# Access Compliance Report

## Public Rights-of-Way

Intersection ID: 13450	Main Street: S_MCDOWELL_ST	Cross Street: E_MARTIN_LUTHER_KING_JR_BV	Location: W
ADA ID: 986C6E690BE8	Ramp Type: PerpDiag	Initial Pass/Fail: Fail	Overall Compliance: No
Codes/Mitigation Info/Possible Solution		Field Measurements/Component Compliance	
Severity Score: 8.75

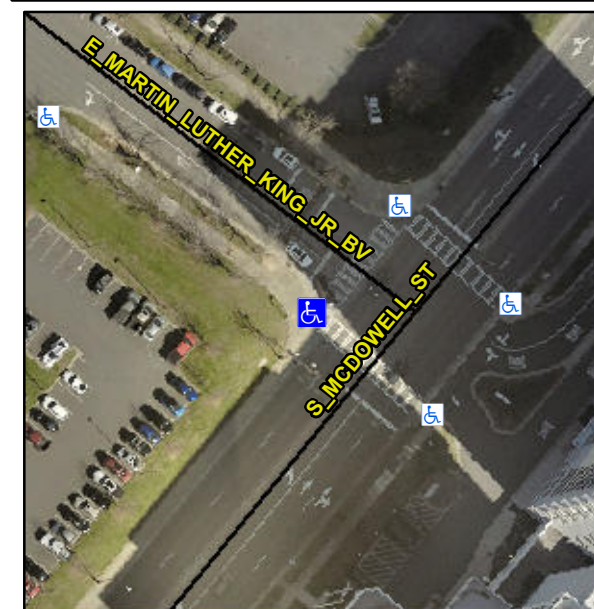
**Not Found, R304.5.1**

Compliance	Description	Data	Compliance	Description	Data
N/A	Ramp Length (in)	57.0	Yes	Ramp Slope (%)	6.1
No	Ramp Width (in)	37.0	Yes	Ramp XSlope (%)	1.5
N/A	Flare Type LT	N/A	N/A	Flare Type RT	N/A
N/A	Flare Slope LT (%)	N/A	N/A	Flare Slope RT (%)	N/A
N/A	Flare Traversable LT?	N/A	N/A	Flare Traversable RT?	N/A
N/A	Landing Length (in)	N/A	N/A	DWS Provided?	N/A
N/A	Landing Width (in)	N/A	N/A	DWS Contrast?	N/A
N/A	Landing Slope (%)	N/A	N/A	DWS Length (in)	N/A
N/A	Landing X Slope (%)	N/A	N/A	DWS Full Width?	N/A
N/A	Landing Curb? (Y/N)	N/A	N/A	DWS Offset (in)	N/A
N/A	Shared Landing?	N/A			
N/A	Gutter Ponding?	N/A	N/A	Gutter Slope (%)	N/A
N/A	Gutter Lip Ht (in)	N/A	N/A	Gutter X Slope (%)	N/A
N/A	Painted X Walk1?	Yes	N/A	Painted X Walk2?	Yes
	X Walk 1 Direction	To SE		X Walk 2 Direction	To NE
N/A	X Walk 1 Width (in)	111.0	N/A	X Walk 2 Width (in)	120.0
	X Walk 1 Slope (%)	1.6		X Walk 2 Slope (%)	0.1
	X Walk 1 X Slope (%)	1.4		X Walk 2 X Slope (%)	0.7

**Remove & Replace Curb Ramp With Two New Directional Ramps or Equivalent.**
